DOCUMENT 009113.01 – ADDENDUM 01

- A. Project Name: Middle Park High School Summer 2026 Renovation
 - 1. Owner: East Grand School District No. 2
 - 2. Owner Project Number <Owner Project Number>.
 - 3. Architect: Hord Coplan Macht (HCM).
 - 4. Architect Project Number: 222000.30

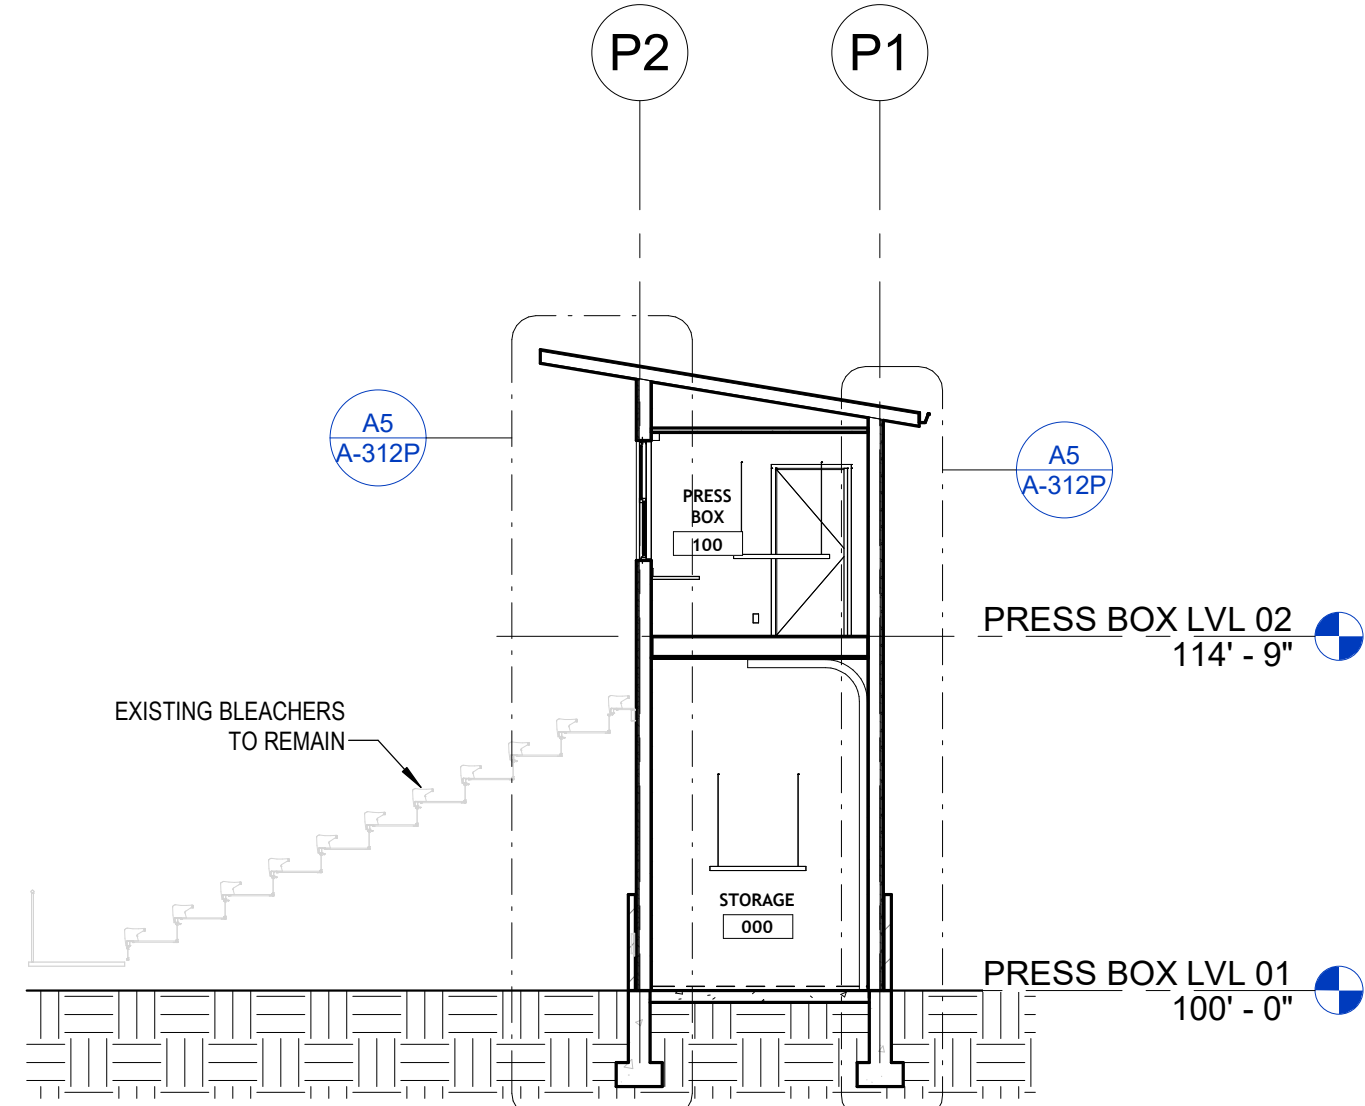
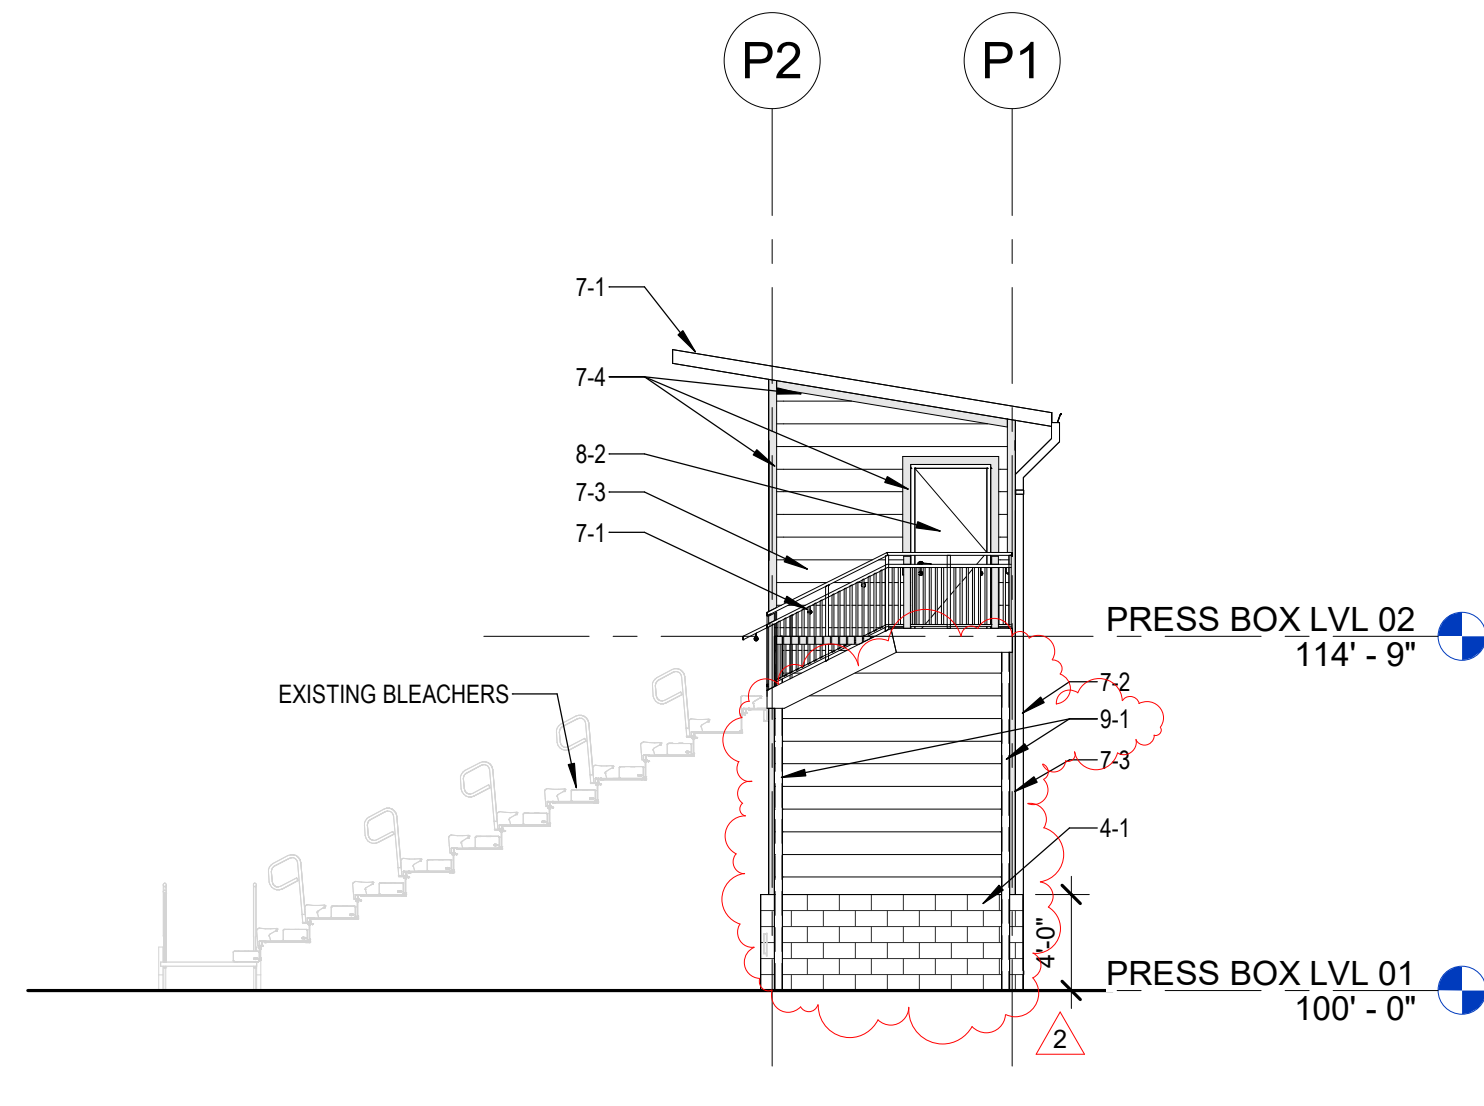
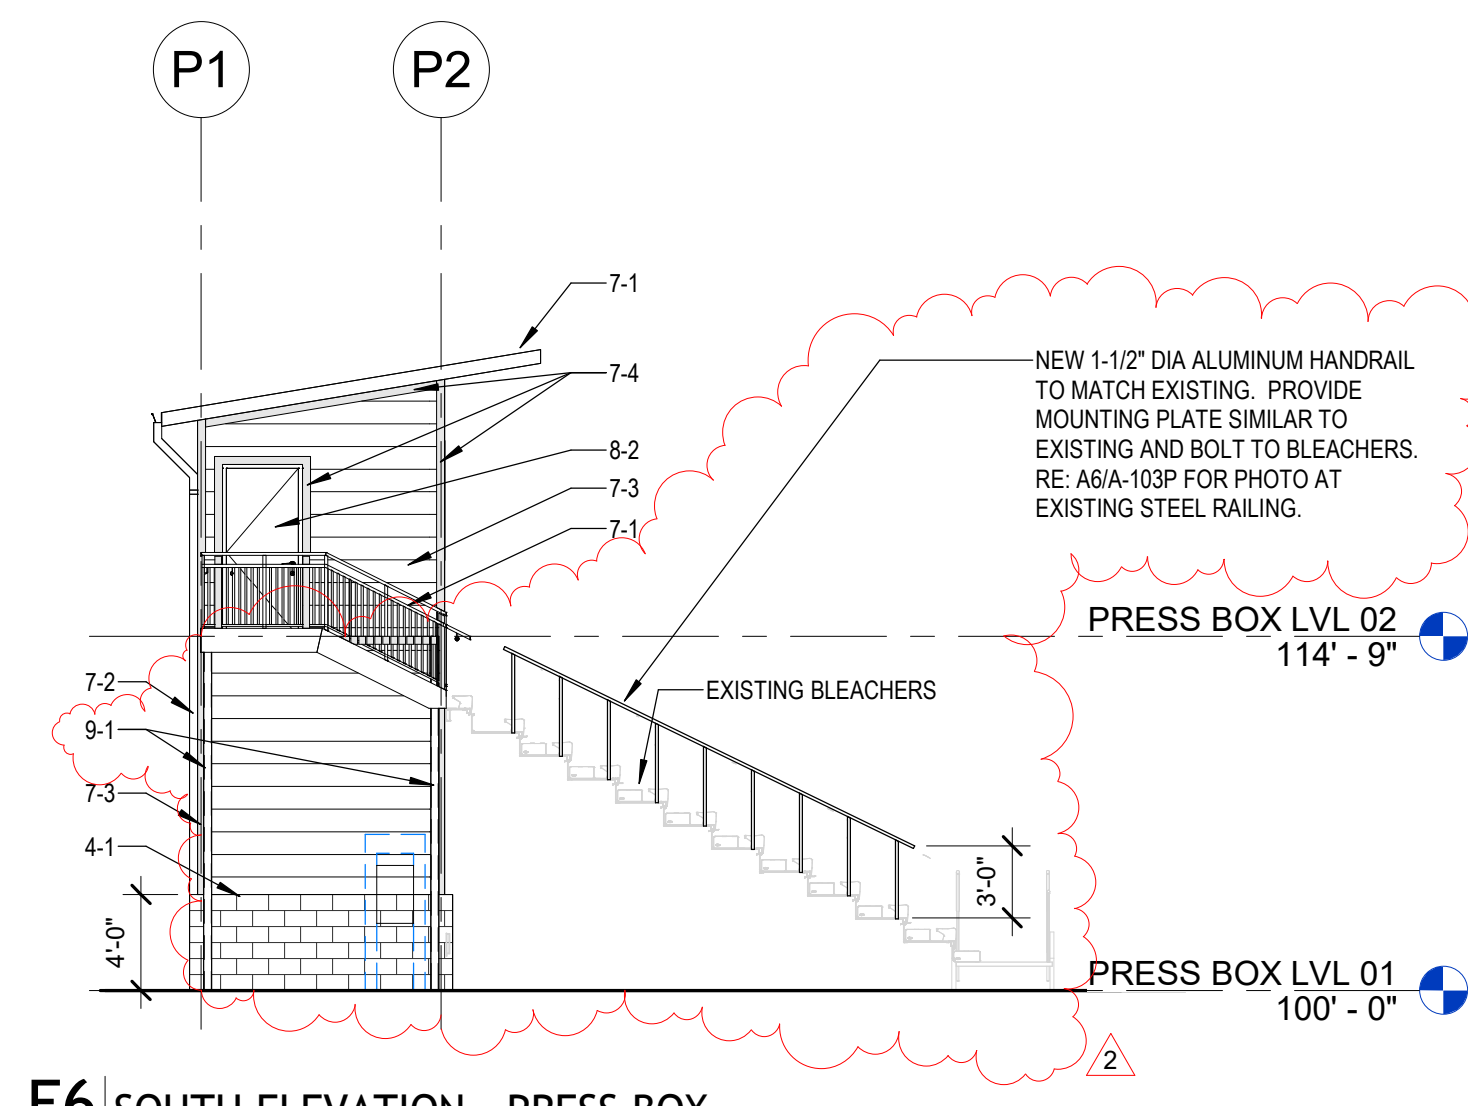
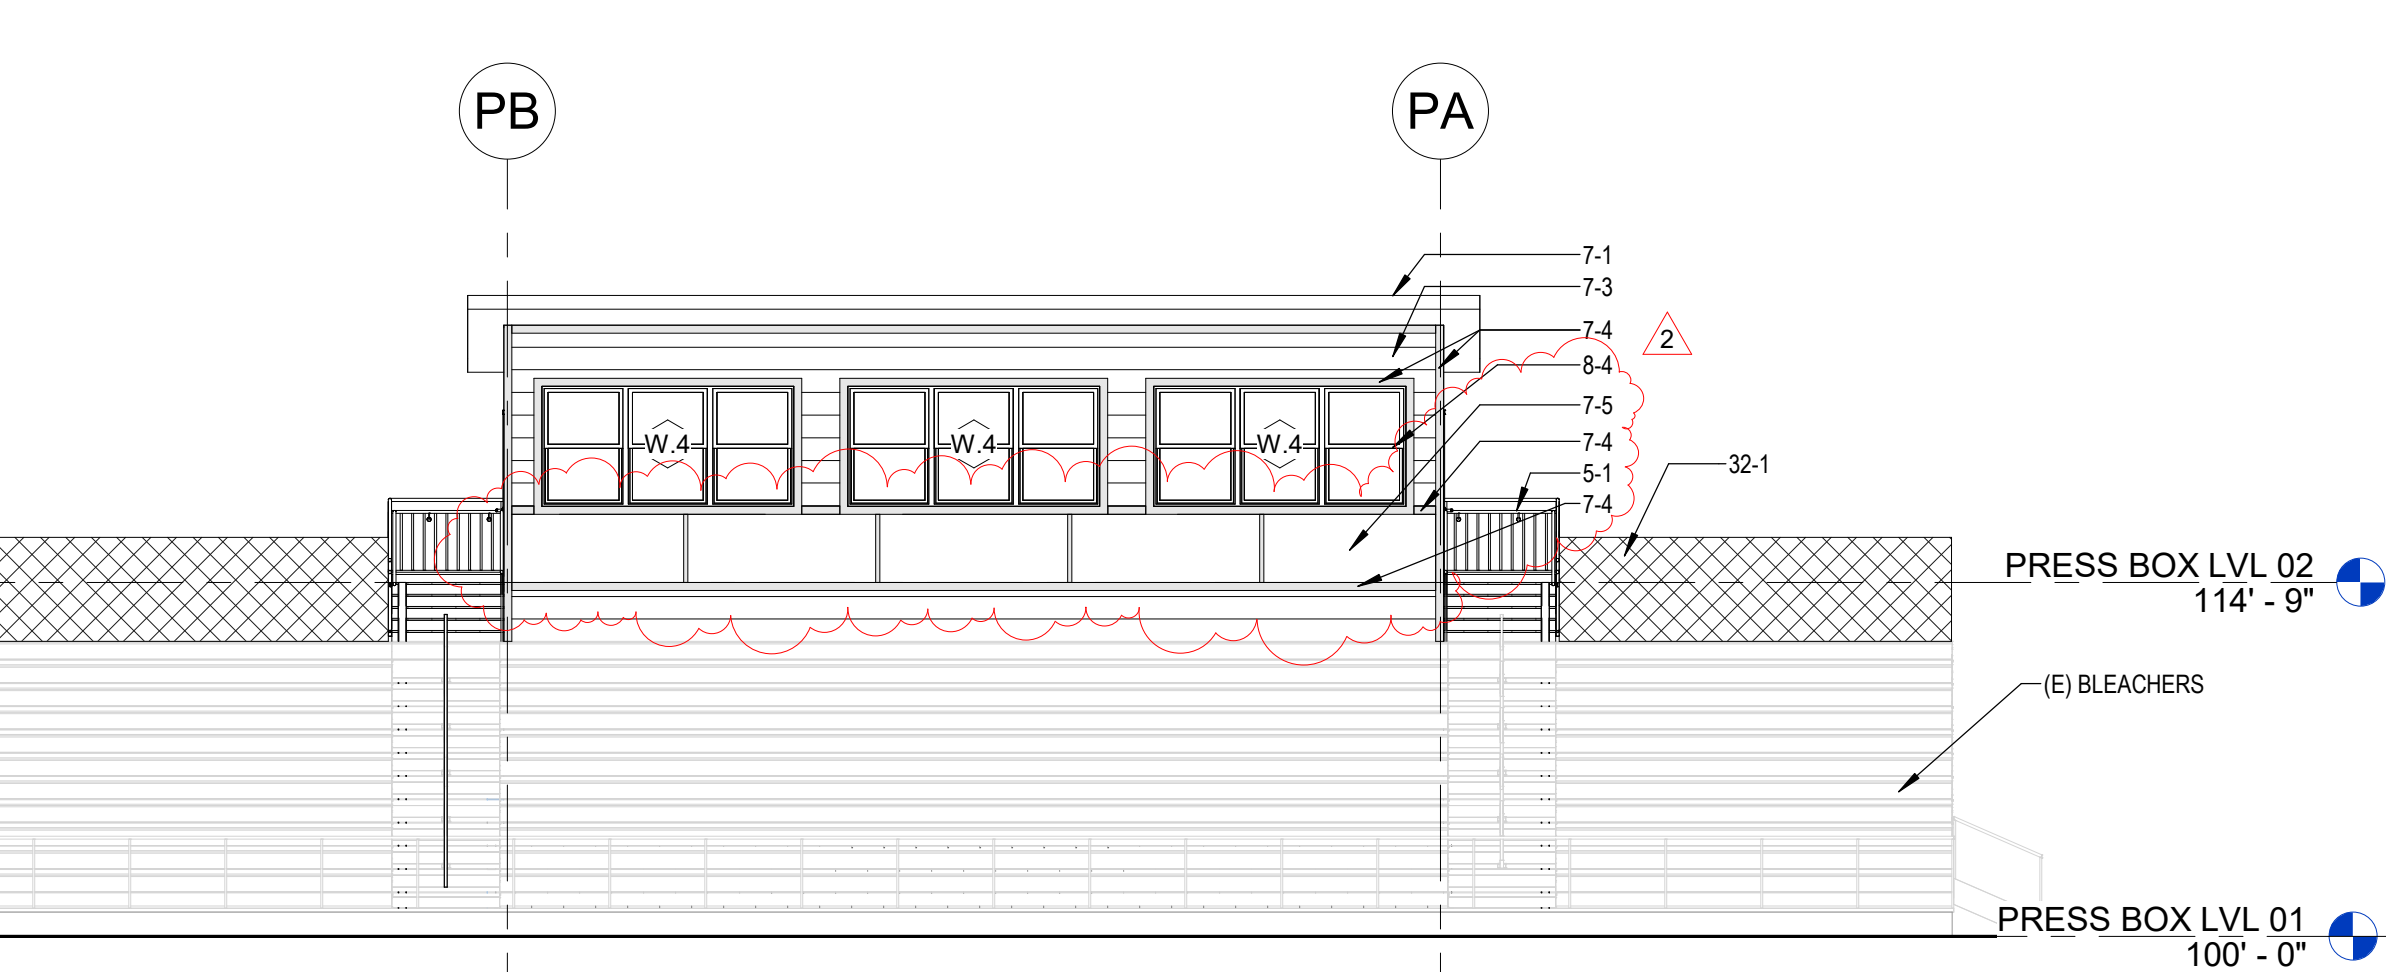
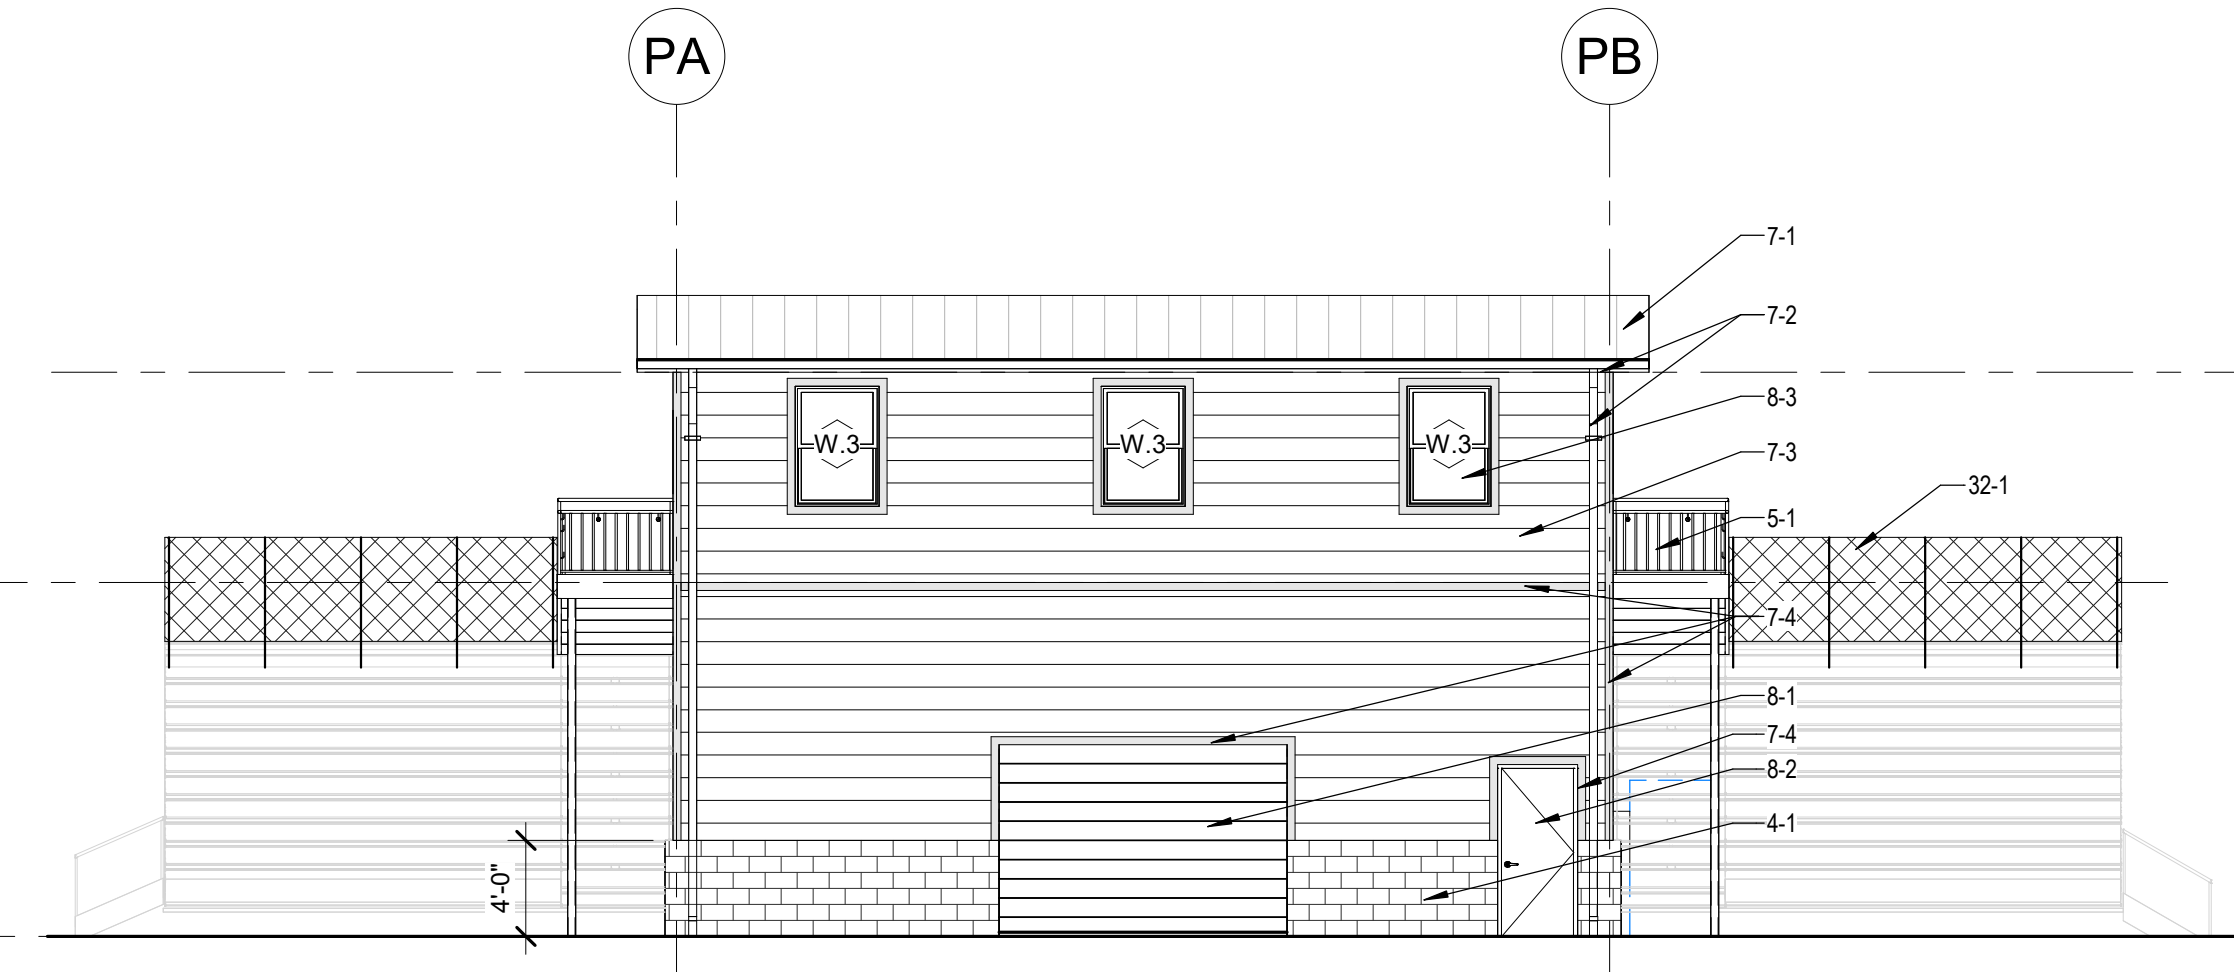
- A. Revision to sheet A-103P.

- 1. Revise sandstone wall extent and pattern as indicated on 1/L3.04 and 4/L3.04.

1. Comment: Press box stairs are shown with exposed steel posts on the structural drawings (sheet S-100), but these posts are not shown on the architectural (sheet A-103P). Please confirm these posts are to be painted along with the stair assembly

2. Comment: Bleacher railing shows new chain-link fabric being installed on existing angle iron (note 32-1/ A103P), please clarify if the existing angle iron will require repair or refinishing.

3. Comment: Press box cement board siding shows color as TBD (note 7-3/A-103P), is this siding to be pre-finished from the factory or field painted?
 - a. Response: All cement board siding to be pre-finished. Cement board is revised under the press box windows adjacent to the top row of bleacher seats to be flush panel, rather than lap siding. See updated material notes and drawings on sheet A-103P. Revised window schedule and details provided on updated sheet A-611P.

4. Comment: Existing bleachers show new aluminum handrail on one side, is this handrail expected to match the existing bleacher handrailing? If so, please provide an elevation or attachment detail of the existing railing if possible.

- a. Response: Steel columns are added to the press box drawings and called out to have high performance coating, with added material note 9-1. See attached revised sheet A-103P.

- a. Response: Intent is to retain structural angle posts for the bleachers. There does not appear to be an alternative solution to mount the fabric fence. These posts are assumed to be in good condition but will need to be observed in field to confirm. Posts to be painted with high performance coating. Revised sheet A-103P incorporates these updates.

- a. Response: The intent is to match the same handrail profile. The existing handrail and attachment are steel. The intent is for the new handrail to be aluminum to match the bleacher system and prevent rusting. Elevation of railing added to the press box drawings, and a photo of the existing post mounting added to sheet A-103P.
